Access Compliance Report

Public Rights-of-Way

Intersection ID: 14872	Main Street: DILWORTH_RD_EAST	Cross Street: ISLEWORTH_AV	Location: NW
ADA ID: 47D212DC1F0E	Ramp Type: ParaDiag	Initial Pass/Fail: Fail	Overall Compliance: No
Codes/Mitigation Info/Possible Solution		Field Measurements/Component Compliance	
Severity Score: 12.5

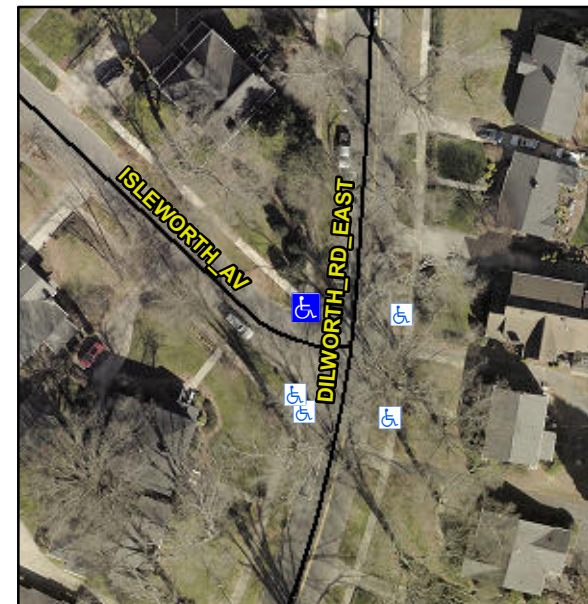
R304.3.2

Compliance	Description	Data	Compliance	Description	Data
N/A	Ramp Length LT (in)	51.0	N/A	Ramp Length RT (in)	N/A
Yes	Ramp Width LT (in)	52.0	N/A	Ramp Width RT (in)	N/A
No	Ramp Slope LT (%)	8.6	N/A	Ramp Slope RT (%)	N/A
Yes	Ramp XSlope LT (%)	1.2	N/A	Ramp XSlope RT (%)	N/A
N/A	Landing Length (in)	N/A	N/A	DWS Provided?	N/A
N/A	Landing Width (in)	N/A	N/A	DWS Contrast?	N/A
N/A	Landing Slope (%)	N/A	N/A	DWS Length (in)	N/A
N/A	Landing X Slope (%)	N/A	N/A	DWS Full Width?	N/A
N/A	Landing Curb? (Y/N)	N/A	N/A	DWS Offset (in)	N/A
N/A	Shared Landing?	N/A			
N/A	Gutter Ponding?	N/A	N/A	Gutter Slope (%)	N/A
N/A	Gutter Lip Ht (in)	N/A	N/A	Gutter X Slope (%)	N/A
N/A	Painted X Walk1?	No	N/A	Painted X Walk2?	No
	X Walk 1 Direction	To S		X Walk 2 Direction	To E
N/A	X Walk 1 Width (in)	N/A	N/A	X Walk 2 Width (in)	N/A
	X Walk 1 Slope (%)	2.8		X Walk 2 Slope (%)	1.2
	X Walk 1 X Slope (%)	1.3		X Walk 2 X Slope (%)	3.0
N/A	Ramp inside XWalk1?	N/A	N/A	Ramp inside XWalk2?	N/A

Remove & Replace Curb Ramp With Two New Directional Ramps or Equivalent.
